# Access Compliance Report

## Public Rights-of-Way (Curb Ramps)

Intersection ID: 10037358	Main Street: SAVANNAH_HILLS_DR	Cross Street: DONNELAITH_LN	Location: W
ADA ID: CC70C3BB2ACE	Ramp Type: PerpDiag	Initial Pass/Fail: Fail	Overall Compliance: No
Severity Score: 25			
Codes/Mitigation Info/Possible Solution		Field Measurements/Component Compliance

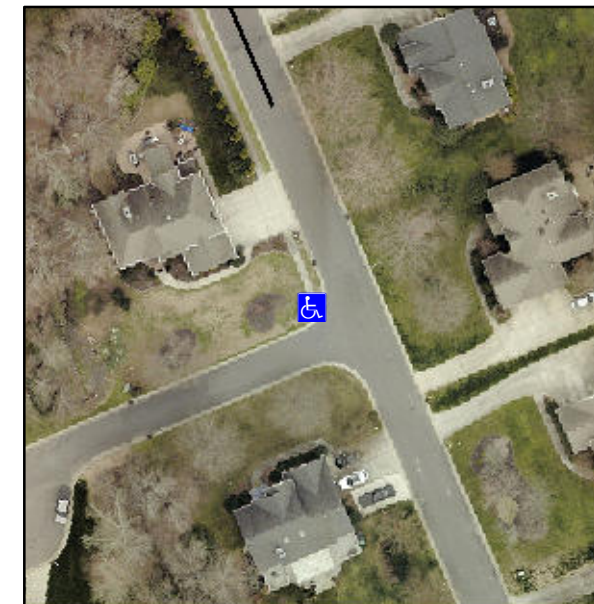
**R304.2.2, R304.5.3**

Compliance	Description	Data	Compliance	Description	Data
N/A	Ramp Length (in)	97.0	No	Ramp Slope (%)	8.4
Yes	Ramp Width (in)	48.0	No	Ramp XSlope (%)	5.5
N/A	Flare Type LT	N/A	N/A	Flare Type RT	N/A
N/A	Flare Slope LT (%)	N/A	N/A	Flare Slope RT (%)	N/A
N/A	Flare Traversable LT?	N/A	N/A	Flare Traversable RT?	N/A
N/A	Landing Length (in)	N/A	N/A	DWS Provided?	N/A
N/A	Landing Width (in)	N/A	N/A	DWS Contrast?	N/A
N/A	Landing Slope (%)	N/A	N/A	DWS Length (in)	N/A
N/A	Landing X Slope (%)	N/A	N/A	DWS Full Width?	N/A
N/A	Landing Curb? (Y/N)	N/A	N/A	DWS Offset (in)	N/A
N/A	Shared Landing?	N/A			
N/A	Gutter Ponding?	N/A	N/A	Gutter Slope (%)	N/A
N/A	Gutter Lip Ht (in)	N/A	N/A	Gutter X Slope (%)	N/A
N/A	Painted X Walk1?	No	N/A	Painted X Walk2?	No
	X Walk 1 Direction	To S		X Walk 2 Direction	To E
N/A	X Walk 1 Width (in)	N/A	N/A	X Walk 2 Width (in)	N/A
	X Walk 1 Slope (%)	2.6		X Walk 2 Slope (%)	7.0
	X Walk 1 X Slope (%)	4.0		X Walk 2 X Slope (%)	2.1

N/A	Ramp inside XWalk1?	N/A	N/A	Ramp inside XWalk2?	N/A
	Road Slope (%)	3.1	N/A	Clear Space?	N/A
	Road X Slope (%)	3.5	N/A	Clear Space to XWalk (in)	N/A
N/A	Any Obstructions?	N/A	N/A	Storm Grate/Utility Hazard?	N/A
	Obstruction Type			Storm Grate/Utility Type	
		N/A			N/A
			Yes	Surface Condition? (G/P)	Good

**Remove & Replace Curb Ramp With Two New Directional Ramps or Equivalent.**
